# SERVICE BULLETIN

No. 566

Piper Aircraft Corporation

Subject: Edo-Aire Mitchell Service Bulletin No. MB-13, dated May 3, 1977; Modification to Edo Aire Mitchell NSD-360 Horizontal Situation Indicator.

**SKETCH "A" APPROXIMATE LOCATION OF NAV FLAG ADAPTER 1C775**  
(View Looking At Left Side Of Upper Forward Fuselage Section)

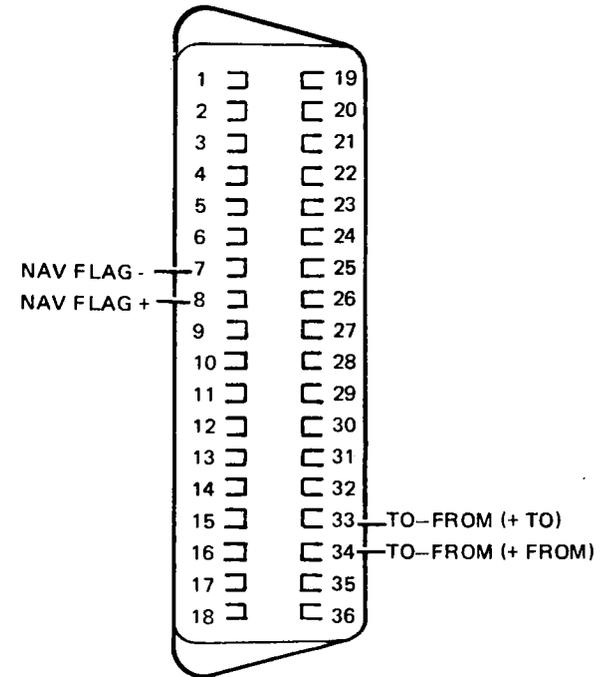
Refer to Sketch "A" of this service release for recommended Nav Flag Adapter unit location and installation.

NOTE: Refer to page two of Edo Aire Mitchell MB-13 for details on mounting the NAV Flag Adapter 1C775.

**IC775  
NAV FLAG ADAPTER  
CD-151**

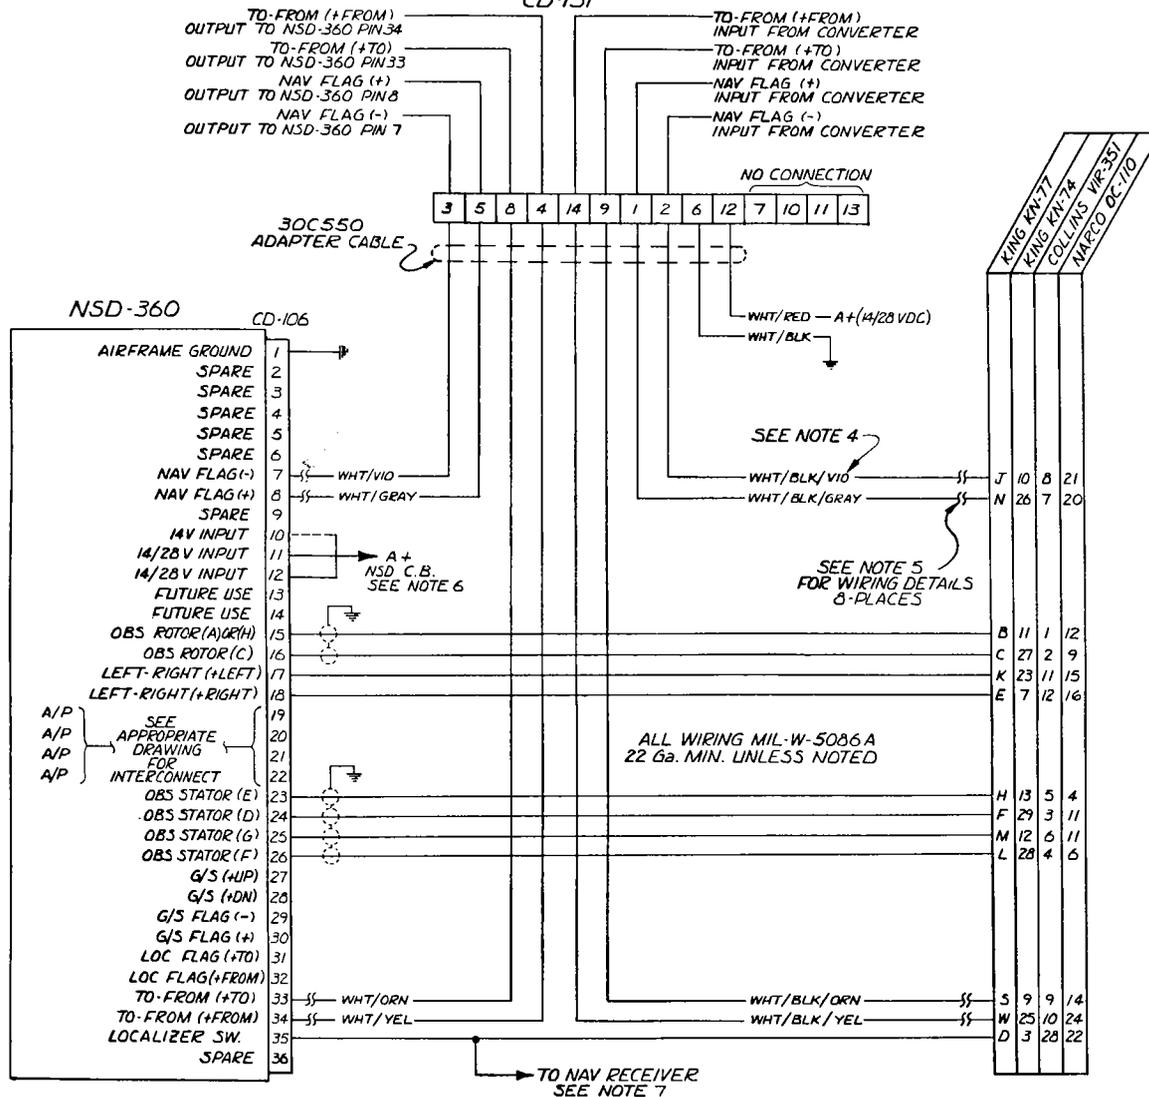
1. Wiring Instructions: Refer to Drawing 63D337-2, on Page eight of MB-13 for a pictorial representation of the following instructions: Also, refer to attached sketch "B" for supplemental view of CD-106 plug.
  - a. Disconnect plug CD-106 from rear of the NSD-360 unit and remove all necessary cable restraints for approximately eight inches to obtain sufficient cable freedom.
  - b. Locate the wire routed from pin seven of CD-106 and cut this wire approximately six inches from the plug. Locate the WHT/VIOLET wire in the 30C550 cable harness and attach it to the six inch wire leading from pin seven of CD-106. Use the 29S59 butt splice to make all connections.
  - c. Locate the WHT/BLK/VIOLET wire in the 30C550 cable and attach it to the other half of the wire that was attached to pin seven in "b", above.

3. Secure the unit to the aircraft structure, using two each of the 8-32 screws, washers, and nuts supplied with PKMB-13.
4. Drawing No. 63D337-2 shows the interconnect wiring between the NSD-360 navigation instrument and the 1C775 NAV Flag Adapter. The four wires indicated, which are a part of the cable bundle to CD-106 of the NSD-360, are to be intercepted as close as feasible to CD-106, and the leads of Adapter Cable, P/N 30C550, are to be connected as shown on Drawing No. 63D337-2. Plug the CD-151 Plug of the 30C550 Cable into the CD-151 Receptacle of the 1C775 NAV Flag Adapter. Route the cable to CD-106 of the NSD-360, leaving sufficient service loop to adequately secure the cable. Cut the wire leads to the proper length and connect to the NSD-360 cable leads as shown using eight 29S59 butt splices. The ground lead of the 30C550 Cable should be routed to a convenient airframe ground. The A+ lead should be connected to the circuit breaker of the navigation receiver that is associated with the NSD-360. Do not connect the A+ to the NSD-360 circuit breaker!

- d. Locate the wire routed from pin eight at CD-106, and cut this wire approximately six inches from the plug. Locate the WHT/GRY wire in the 30C550 cable and attach it to the six inch wire leading from pin eight.

- e. Locate the WHT/BLK/GRY wire in the 30C550 cable and connect it to the other half of the wire that was attached to pin eight in "d", above.
  - f. Locate the wire routed from pin 33 of CD-106, and cut this wire approximately six inches from plug CD-106. Locate the WHT/ORG wire in the 30C550 cable and attach it to the six inch wire leading from pin 33.

- g. Locate the WHT/BLK/ORG wire in the 30C550 cable and connect it to the other half of the wire that was attached to pin 33 in "f", above.
  - h. Locate the wire routed from pin 34 of CD-106, and cut this wire approximately six inches from the plug. Locate the WHT/YEL wire coming from the 30C550 cable and attach it to the six inch wire leading from pin 34.

- i. Locate the WHT/BLK/YEL wire in the 30C550 cable and attach it to the other half of the wire that was attached to pin 34 in "h", above.
  - j. Connect the WHT/RED wire to the appropriate Nav Receiver circuit breaker. DO NOT connect it to the NSD-360 circuit breaker.

- k. Route the WHT/BLK wire to any convenient place and attach it to the airframe, making sure all paint has been removed so there is a good ground.
  - l. Re-tie all wire bundles in an airworthy manner. Ref. Instructions: No. five on Page three of MB-13 (attached).
